ADDENDUM No. 02

Date: February 20, 2019

Coaldale Government Building

Project No.: 9030

AASK1.1

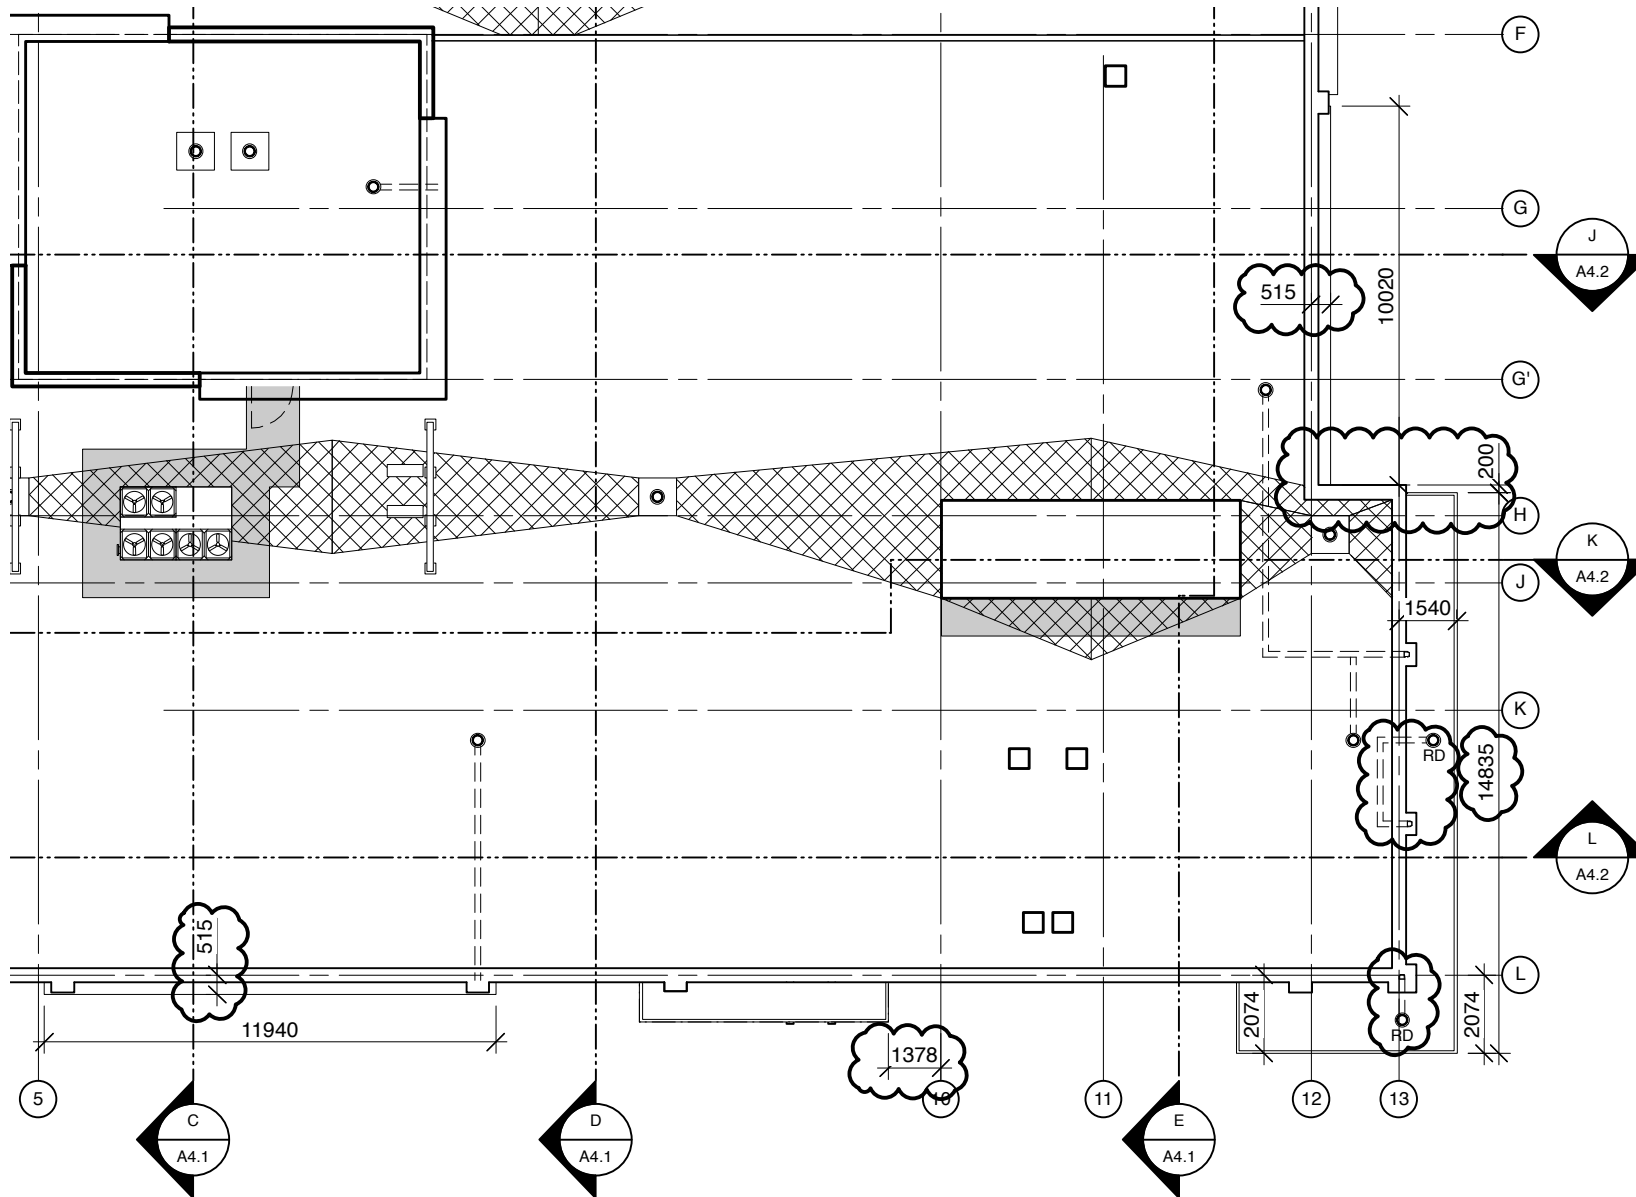
REVISIONS:
1. CANOPY DEPTHS TO BE CHANGED WHERE
CLOUDED. REFER TO SECTION DETAILS
1/AASK1.3 AND 7/A4.5 FOR ROOF TYPE.

AASK1.2

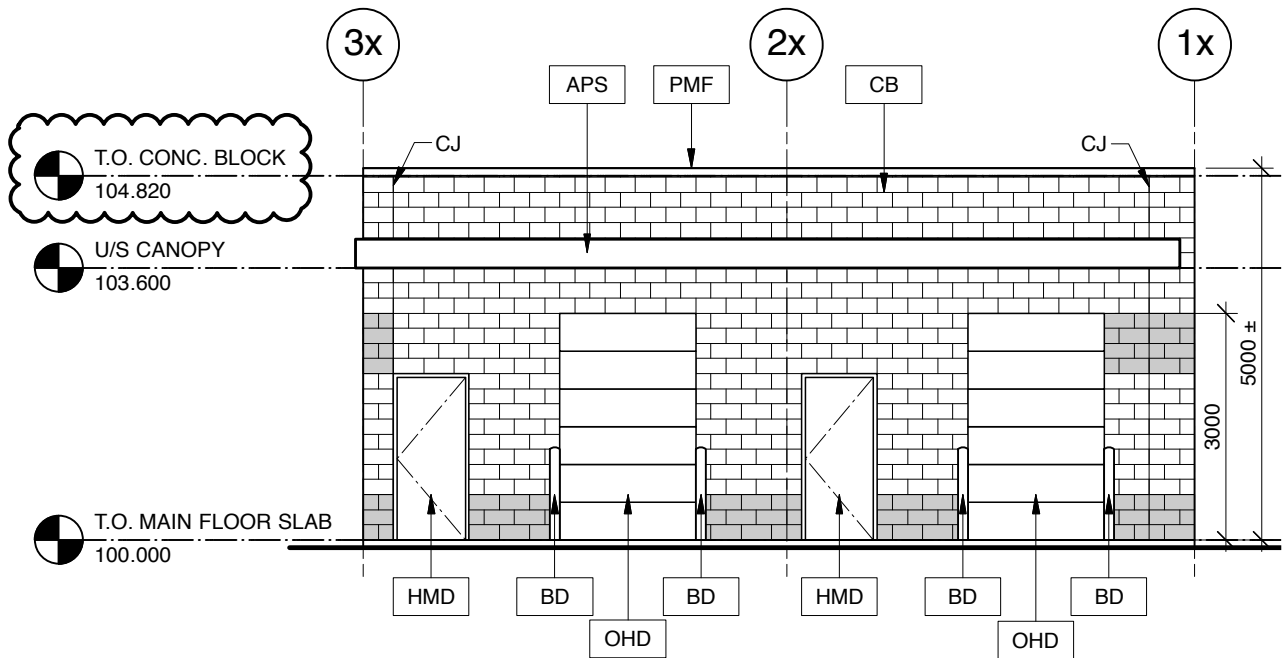
REVISIONS:
1. CANOPY DEPTHS TO BE CHANGED WHERE CLOUDED. REFER TO SECTION DETAILS 1/AASK1.3 FOR ROOF TYPE.
2. ROOF DRAINS ADDED.

1 PARTIAL FLOOR PLAN
Scale: 1:100

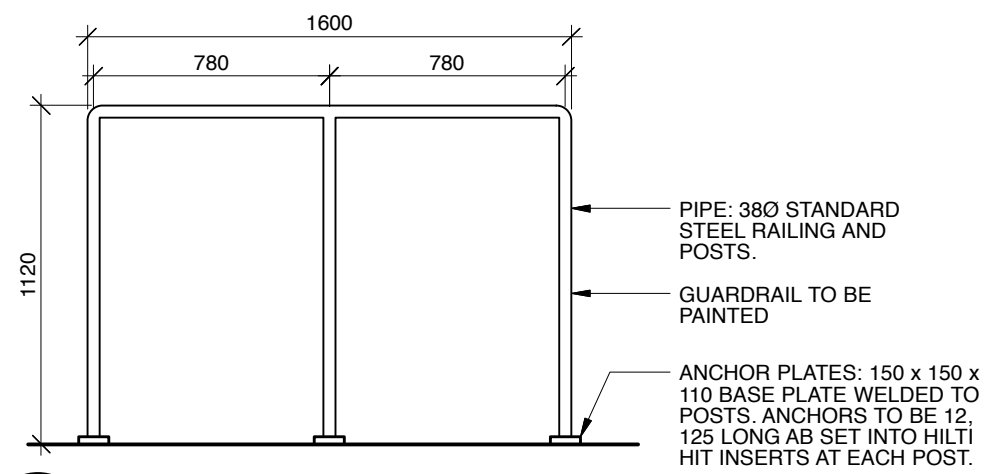
1. OVERHEAD DOOR (OH130) TO BE MOVED NORTH 200mm. SPACE BETWEEN OVERHEAD DOOR AND MAN DOOR IS NOW 600mm.
2. OVERHEAD DOOR MOTOR AND CHAIN ENCLOSURE TO BE RELOCATED TO SOUTH SIDE OF OVERHEAD DOOR.
3. THE CONCRETE APRON WILL EXTEND NORTH 200mm FROM 5800 TO 6000. CONCRETE CURB TO ADJUST ACCORDINGLY.

2R
A2.5
CORRIDOR 106 @ CLERESTORY
Scale: 1:10

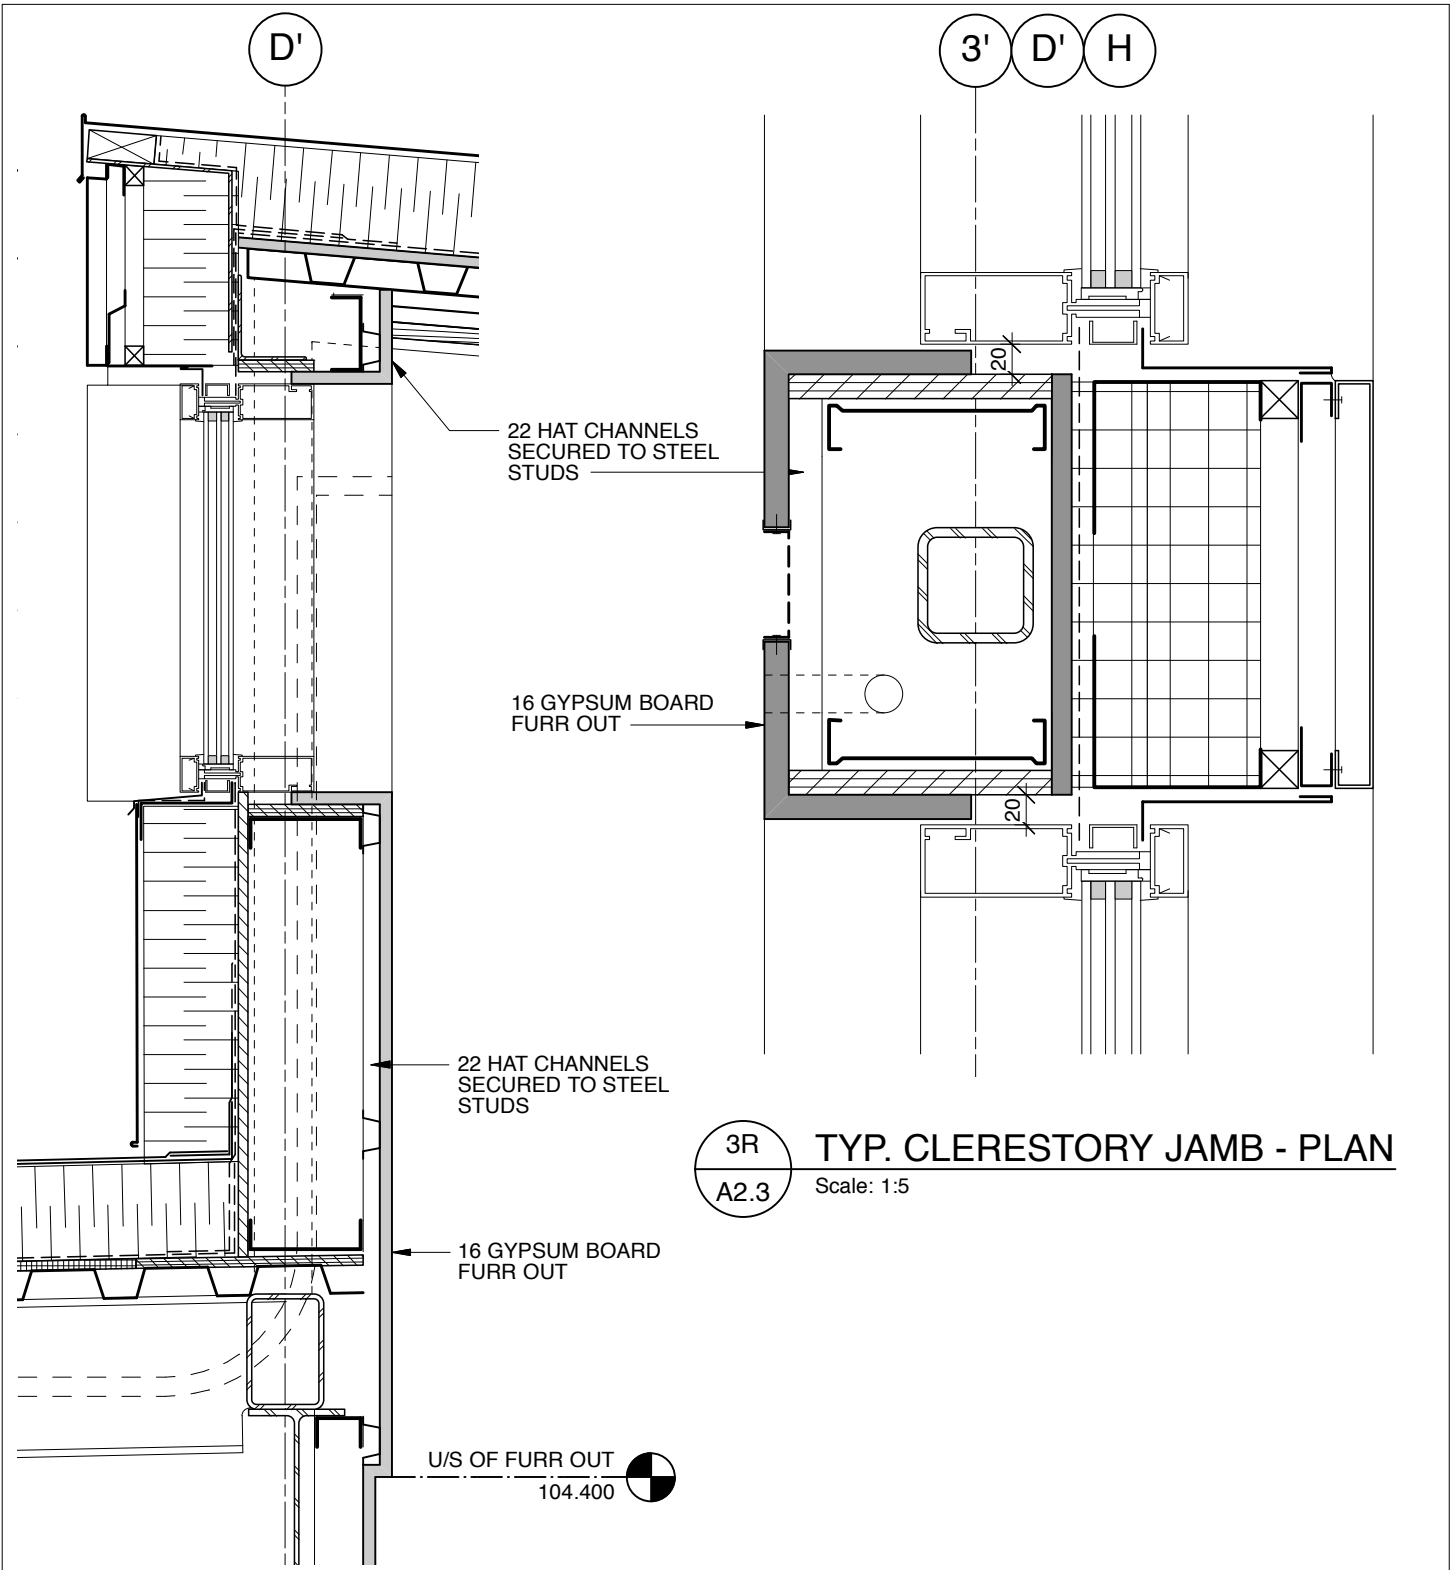
REVISIONS:
1. FURR OUT CLERESTORY WALLS, THAT CONTAIN SPRINKLER LINES, WITH 22 HAT CHANNELS FROM U/S OF DECK TO 104.400. THIS FURR OUT APPLIES TO CLERESTORY WALLS ON GRIDLINES 3', D' AND H.
